Bid#36-19
Spinney Road & Middle Street Sidewalks

Addendum #1
Issued: February 15, 2019

Addendum#1 adds two brick sidewalk sections to the Middle Street Site.

TRENCH NOTES - STORM DRAIN

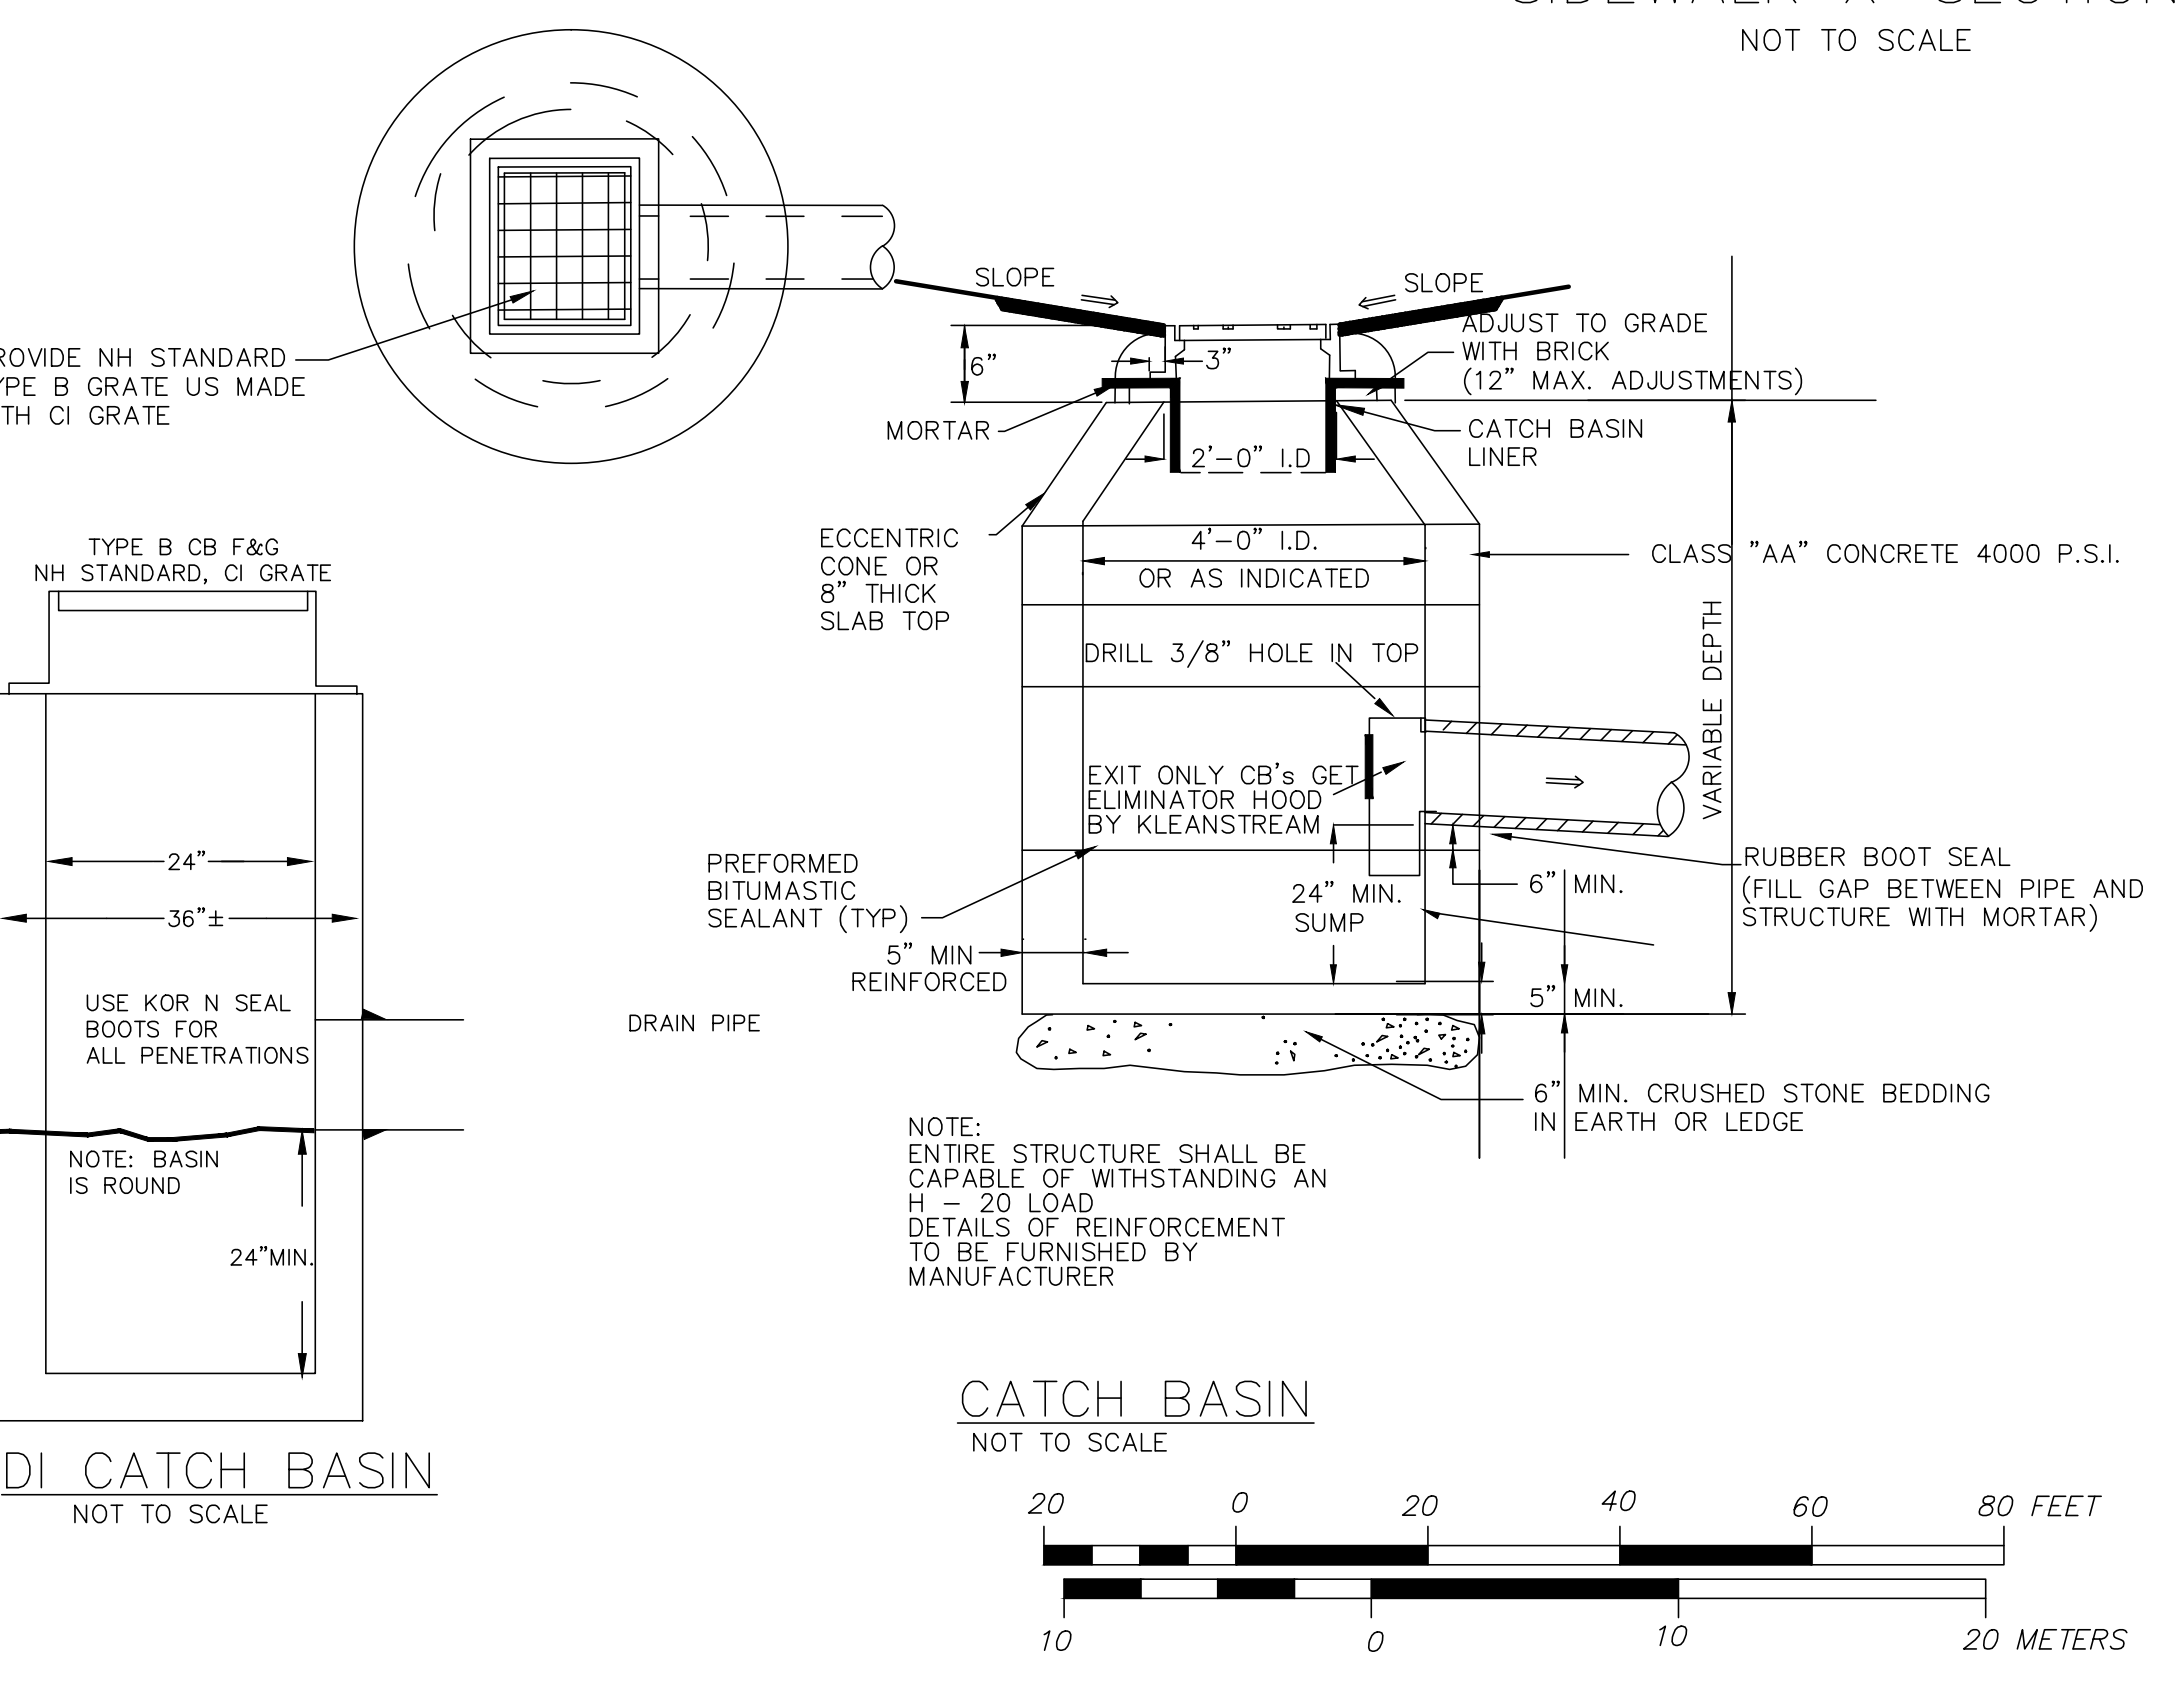
1. The bid proposal pages have been replaced in their entirety.
 - A Brick sidewalk bid item has been added.
 - Projected quantity of concrete sidewalks has been reduced.
 - Additional quantities have been added to Item 403.12 (hand method paving).
2. Added to specifications: SPECIAL PROVISION TO SECTION 608: Section 608.5 Brick Sidewalk.
3. Drawings revised in bid document: Middle Street sheet and detail sheet. See revised sheets 3 and 5 attached.

| REV. NO. | DATE | DESCRIPTION | D.J.D |
|----------|-----------|---------------------------|--------|
| 1 | 2/13/2019 | ADD BRICK SIDEWALK DETAIL | APPR'D |
